Reference: BWP SW25 - Corrective Action Design
Boston Environmental Corporation, Transmittal #X254044
Old Fall River Road Landfill, Dartmouth

We are in receipt of your August 25, 2014 Determination of Technical Incompleteness regarding the Corrective Action Design (CAD) for the Old Fall River Road Landfill in Dartmouth, and are herein responding to it. Responses are primarily revisions to portions of the CAD narrative sections and drawings. The revised sections along with added information are attached as either replacement sections supplemental section to the original June 26, 2014 CAD submission. Specific responses to your comments are as follows.

Project:	452 OLD FALL RIVER ROAD DARTMOUTH, MASSACHUSETTS BOSTON ENVIRONMENTAL CORPORATION 100 HOWARD STREET BOSTON, MASSACHUSETTS
Contract No.:	08/28/14
Issue No.:	AS SHOWN
Date:	MAY 16, 2014
Author:	JAC
Checked:	AKD
Design Number:	DET-1

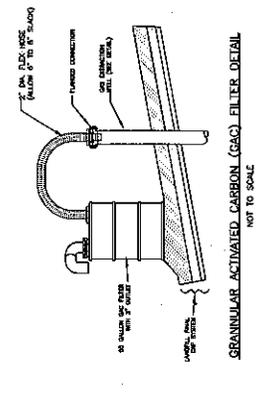
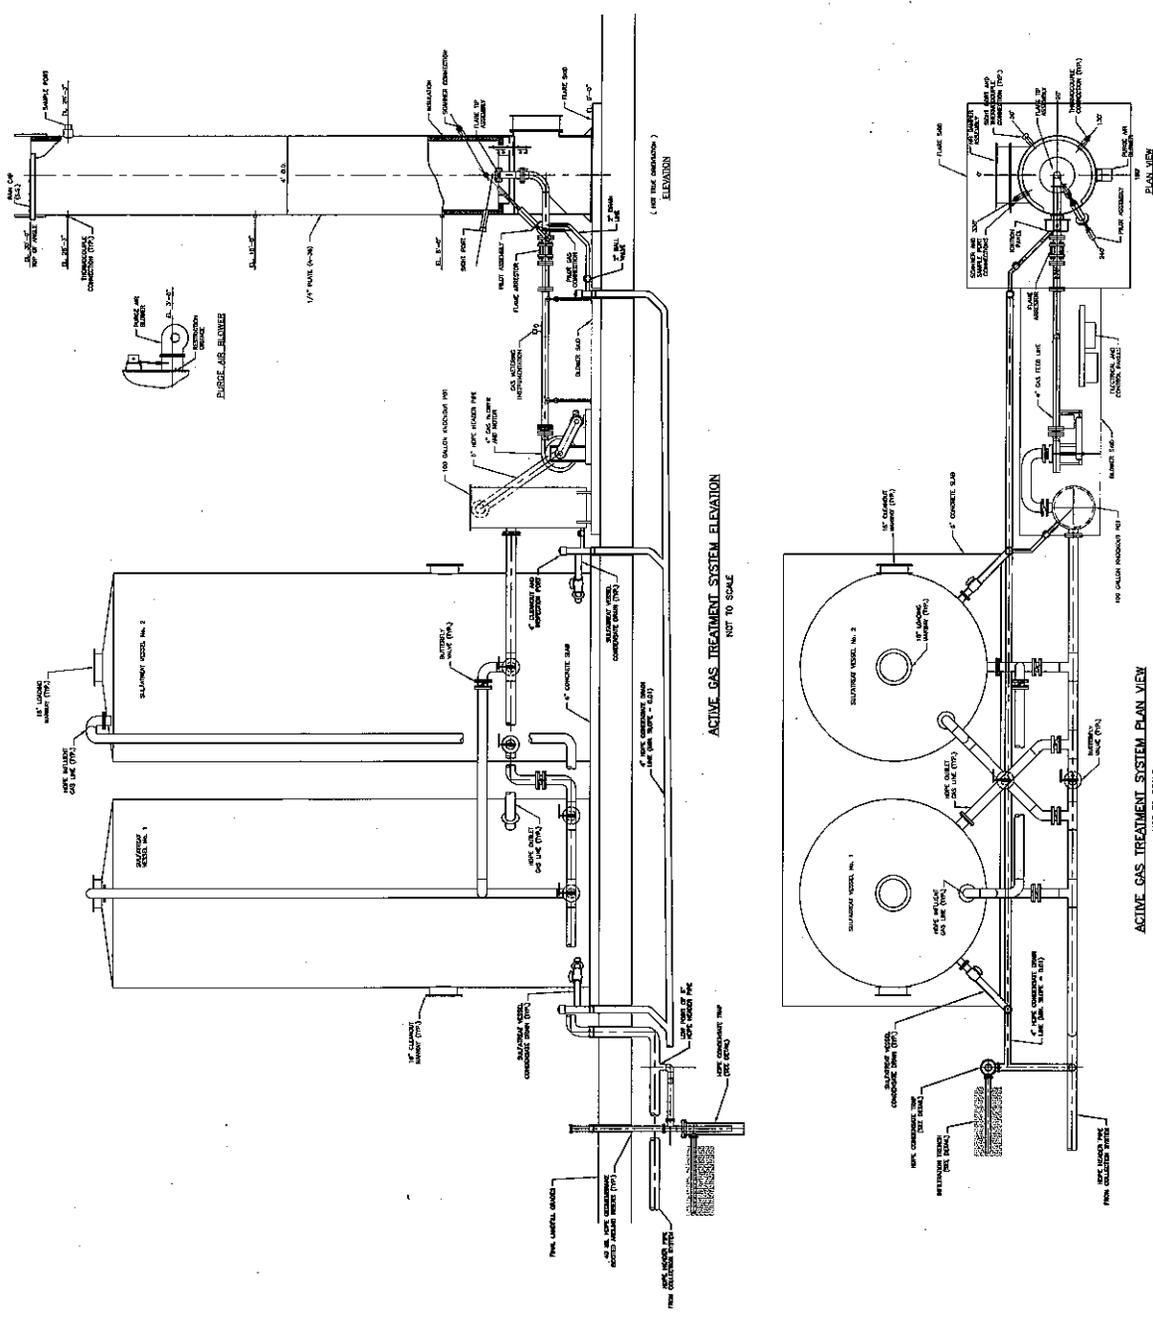
7. Drawing DET-1 provides details for stormwater basin construction. Provide additional details for the basin located above the Landfill final cover system.

8. Drawing DET-1 provides a Let-Down Channel Detail that proposes the use of Emulsion Mix. Provide a description of the Emulsion Mix. Indicate on this detail or on SP-4 the extent of rip-rap to be placed at outlet of the Basin No. 1 and No. 2 let-down channels to prevent scouring.

9. Drawing SP-4 indicates a stormwater collection area and outlet pipe at the base of the Landfill access road. Provide details for this outlet similar to the details on drawing DET-1 for basins 1 and 2. Also supplement the Stream Crossing Replacement Culvert Detail on drawing DET-1 to indicate the extent of the headwall and the extent of rip rap, if any, at the inlet and outlet. State that all road work and culvert work will be performed within the Old Fall River Road Landfill property limits.

7. The Details Plan has been revised to show construction details of stormwater basins where they are within the limit of the geomembrane cap construction.

8. References to Emulsion Mix have been deleted and replaced with Asphalt Pavement Grindings as base material to hold rip rap in place. The let down channel rip rap has been extended within the Basins to eliminate scouring.

9. A detail of the stormwater collection area at the base of the access road has been added to the Details Plan. Additional plan views and details have been added to the stream crossing design. All road work and culvert work will be performed within Old Fall River Road property limits.
